CONSTRUCTION PLANS FOR

NOR ESTE MANOR SUBDIVISION

DRAINAGE, GRADING, PAVING AND UTILITY
IMPROVEMENTS

NOTE:
SHEETS AFFECTED BY CHANGE ORDER #1
AS INDICATED

TITLE
NOR ESTE MANOR
WILSHIRE AVE. N.E. STA. 18+26.69 TO STA. 29+26.69
PAVING PLAN AND PROFILE

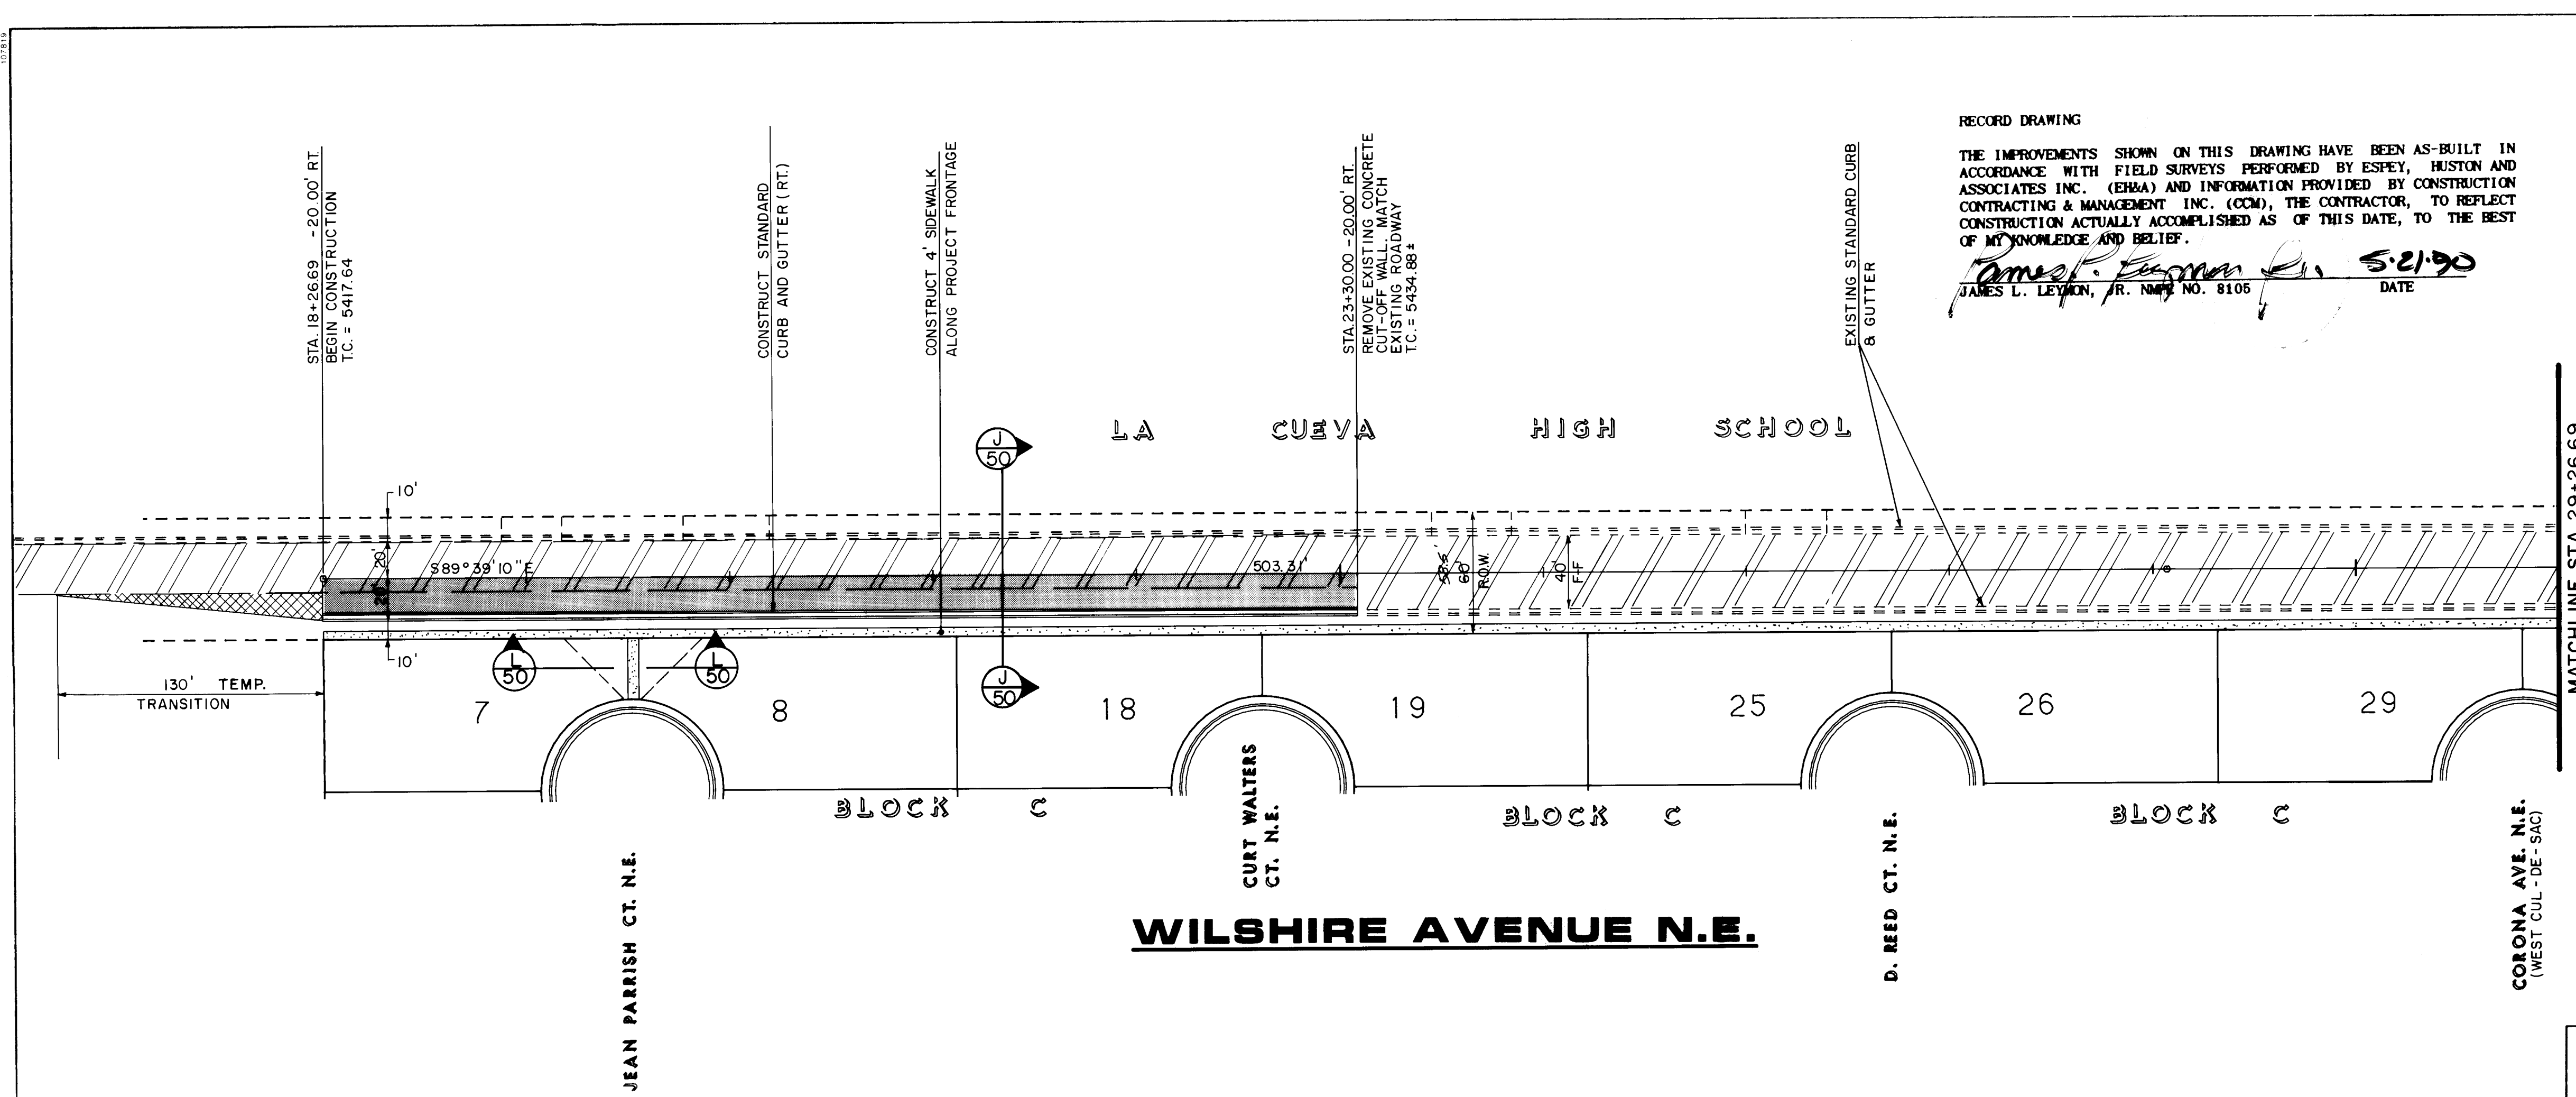
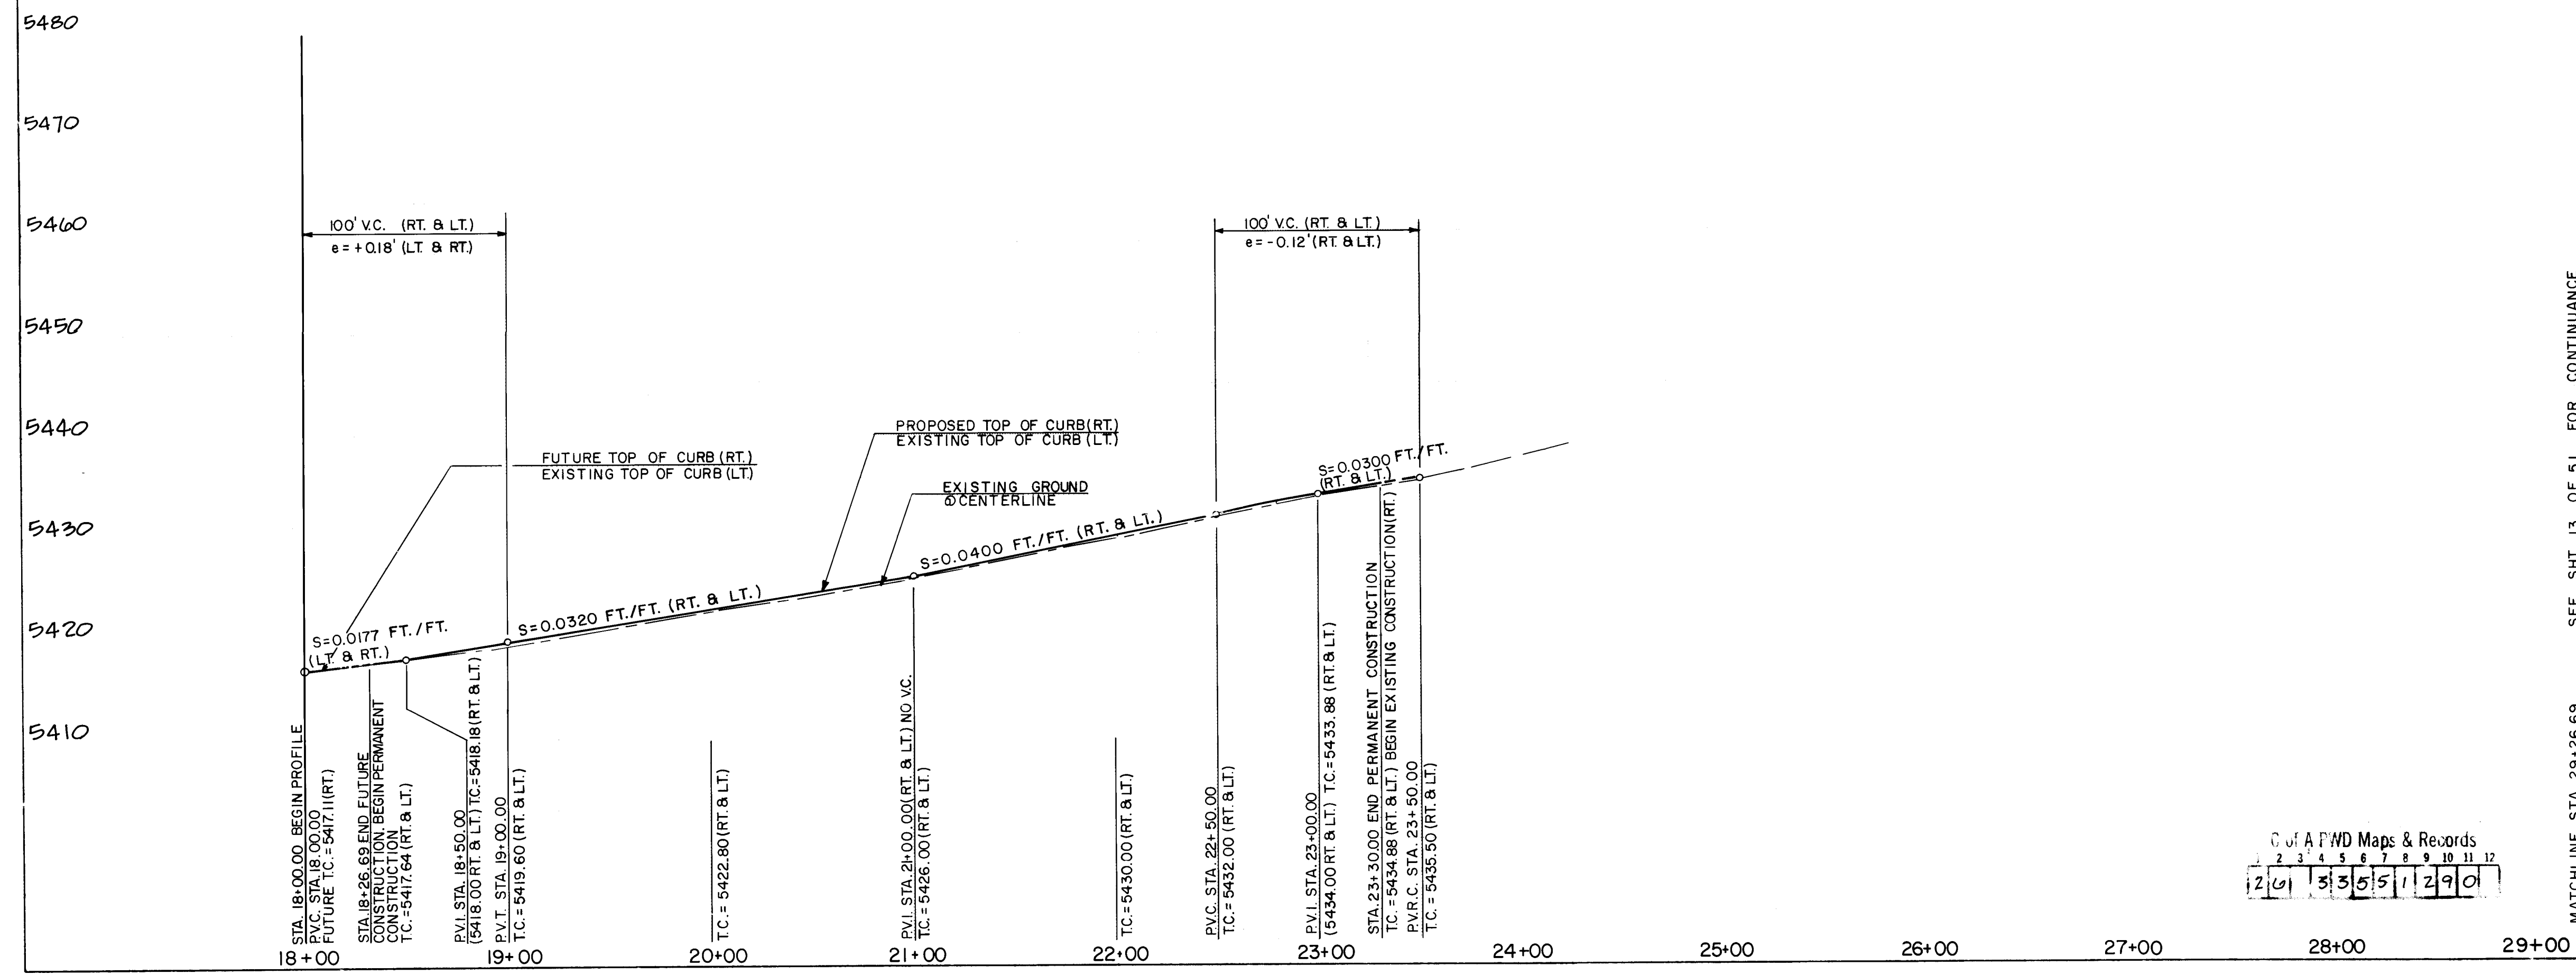
CHANGE ORDER NO. 1
C of A PWD Maps & Records
REVISIONS
ADD SEWERLINE IN CORONA
REVISE SEWERLINE IN JULIAN ROBLES
ANALYSIS STA. 1+65
DELETE MH #4 @ ANAHEIM AND HELEN HARDIN

NOR ESTE MANOR
JEAN PARISH CT. N.E. STA. 0+00.00 TO STA. 5+52.63
PAVING PLAN AND PROFILE

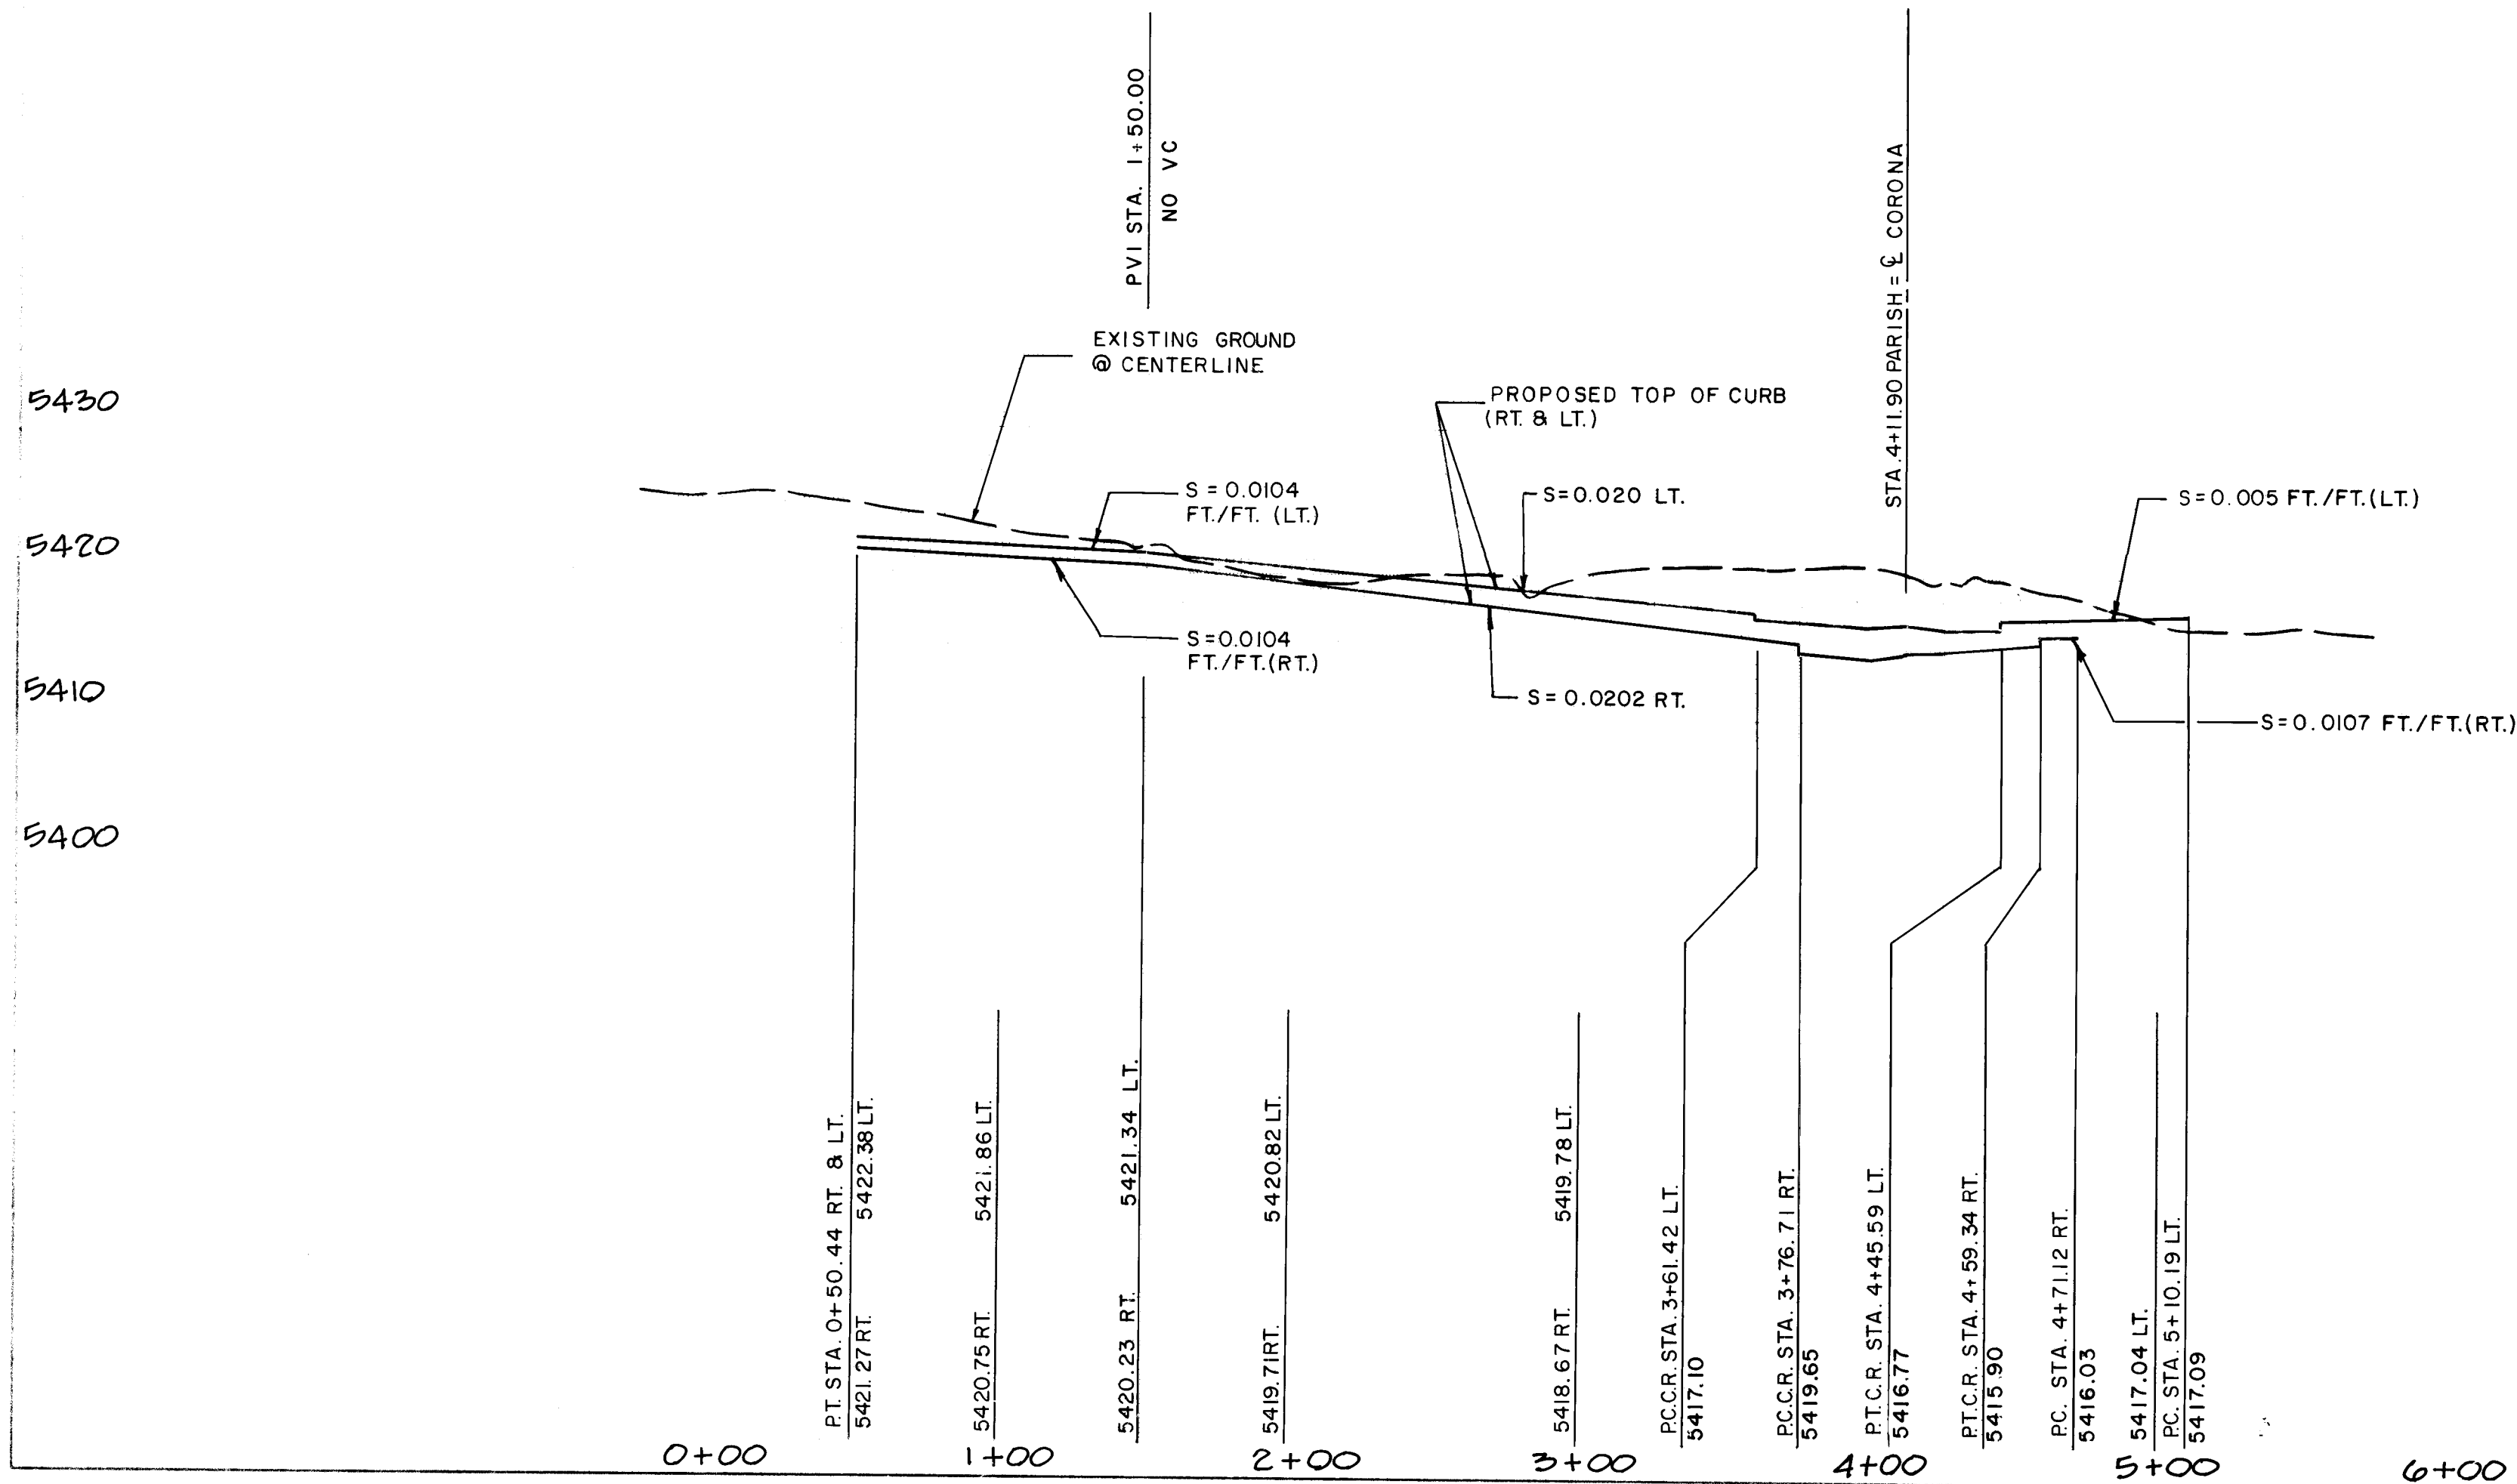
REVISIONS
REGRADE STA. 3+61.42 TO STA. 5+10.19
